**MONTGOMERY COUNTY
PLANNING COMMISSION**

Re: MCPC #19-0162-001
Plan Name: French International School
(1 lot/6,044 sq. ft. institutional on approximately 1.47 acres)
Situate: City Avenue (north)/Bala Avenue (west)
Township of Lower Merion

We have reviewed the above-referenced tentative sketch plan as you requested on June 21, 2019. We forward this letter as a report of our review.

Attachment A: Reduced Copy of Applicant's Proposed Site Plan
Attachment B: Aerial Image of Site

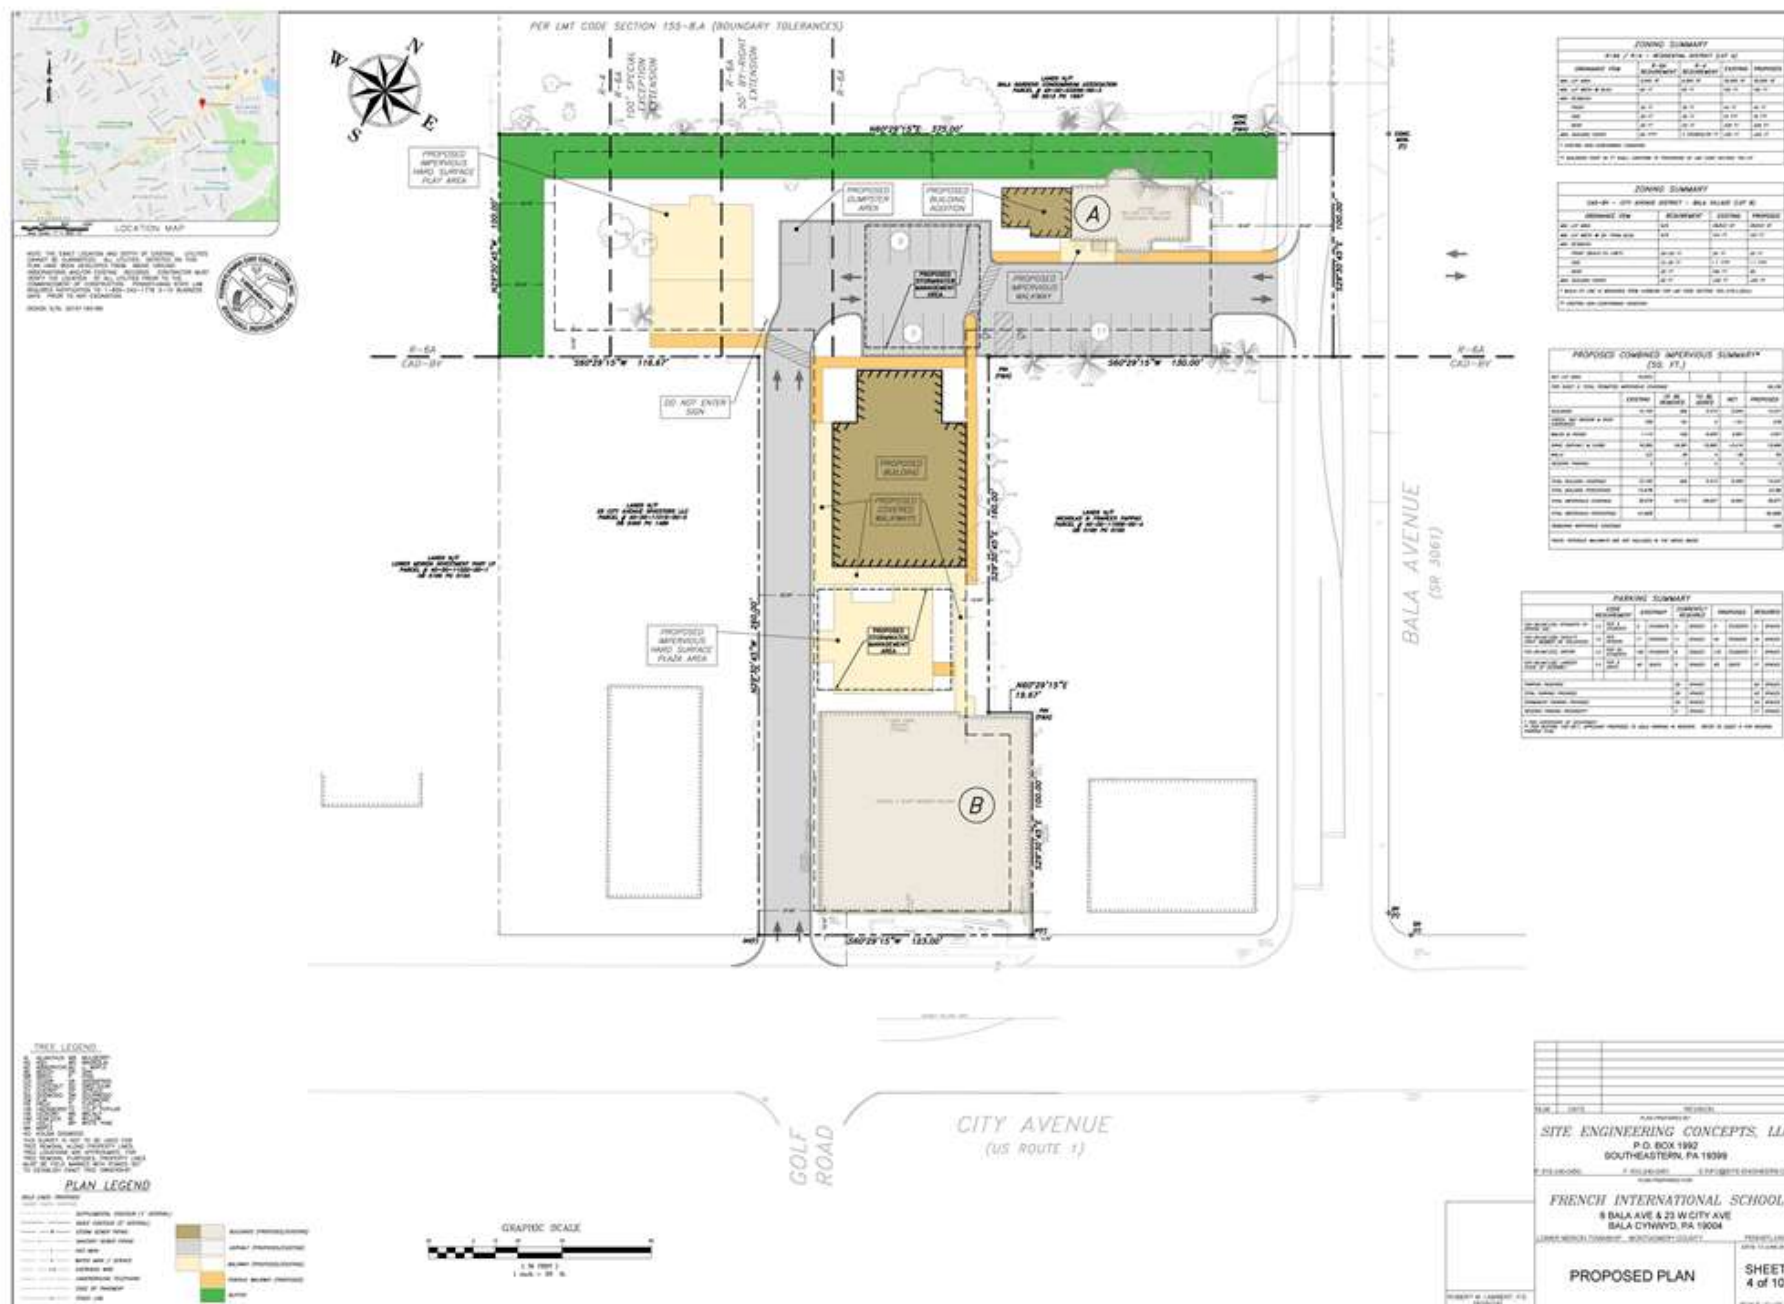
Sidewalk Width and Location. Section 135-28.B. of the township’s Subdivision and Land Development Ordinance states that sidewalks should be located “as far from the curb as is practicable.” It appears that the applicant proposes to construct a 5-foot wide sidewalk abutting the curb along the Bala Avenue frontage of the combined site. We encourage the applicant to widen the sidewalk along the Bala Avenue frontage of the site to at least 5 feet, as shown; however, while maintaining a grass strip between the sidewalk and the curb to buffer pedestrians walking along Bala Avenue from moving traffic.

According to the information provided on Sheet 6 of 10, the applicant proposes to queue buses and passenger vehicles next to each other within the two-lane driveway off of City Avenue. In the proposed vehicle queue configuration, it appears that students exiting the school buses would have to cross the driveway and walk between passenger vehicles to reach the school. In addition, utilizing both lanes of the entrance driveway off of City Avenue could create confusion and traffic back-ups during rush hours if the school buses or vehicles that are queuing back-up on to City Avenue.

Overall, we encourage the applicant to work with the their school bus provider and the township to determine if an alternative school bus drop-off and pick-up location would create a more logical and safer circulation pattern. For example, school buses could queue in the rear parking area where students could disembark and walk down the pedestrian path shown from the rear parking area to the main school building.

Two underground stormwater management facilities are shown on Sheet 4 of 10, including one under the proposed hard surface plaza area between the existing and proposed school buildings. According to the landscape plan on Sheet 8 of 10, several trees are proposed along the perimeter of the plaza that appear to be planted on top of the proposed underground stormwater management facility. We defer to the township engineer to determine if modifications to either the proposed landscaping or the proposed underground stormwater management facility may be needed.
